RUNE PROJECT CALL

REQUEST FOR FINAL OFFER for the supply and integration of active network layer systems

Questions and answers V1_19112019

November 2019

Since the fiber optic cable network topology is not clear, you are kindly asked to precise which of the following physical connectivity diagrams are required for the DWDM network:

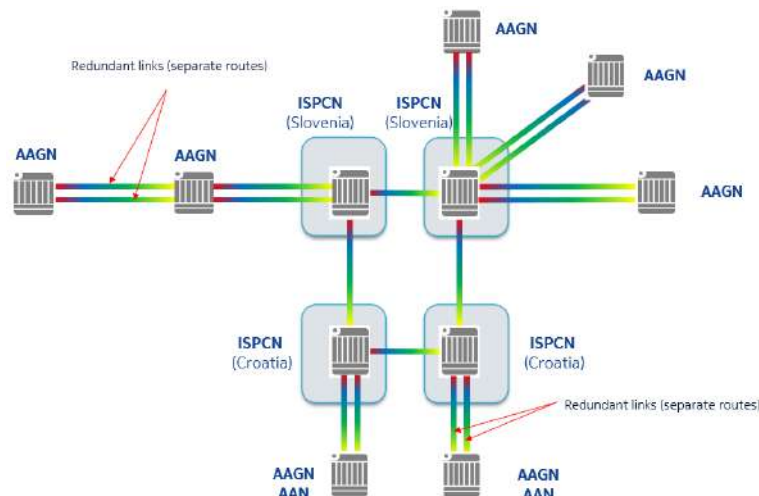
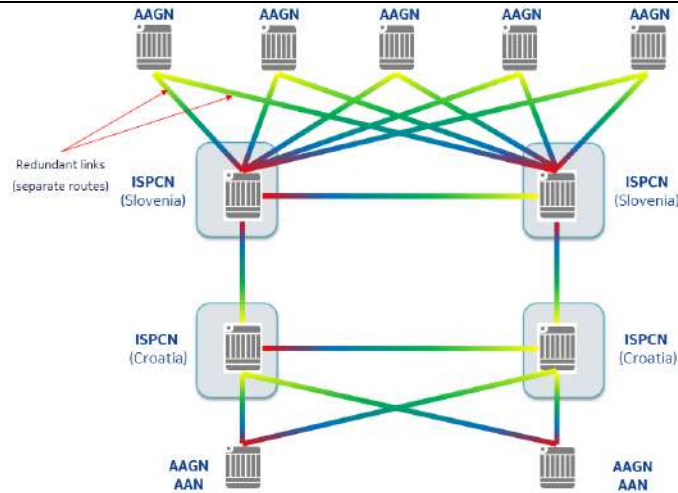
- a. in page 3 is mentioned: five AGGN nodes in Slovenia with multiple AGGN devices, which must have redundant connection to both ISPCN nodes in Slovenia.
- b. in page 7 chapter 1.2 is mentioned that “Connection between ISPCN and each AGGN node is done via two geographically independent fiber connections”.
- c. in page 10, chapter 1.5 it is mentioned that “Each AGGN device must be connected to all ISPCN locations in region”.

Option1:

Option2:

Option 2.

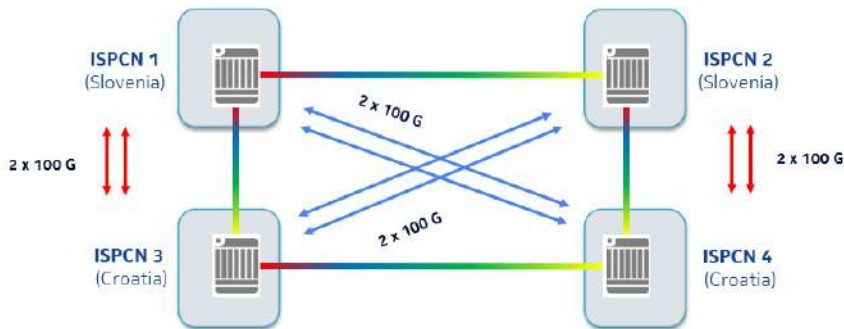
Can you please precise the distance between the two ISPCN locations in Croatia?

67 km, Matulji-Pazin.
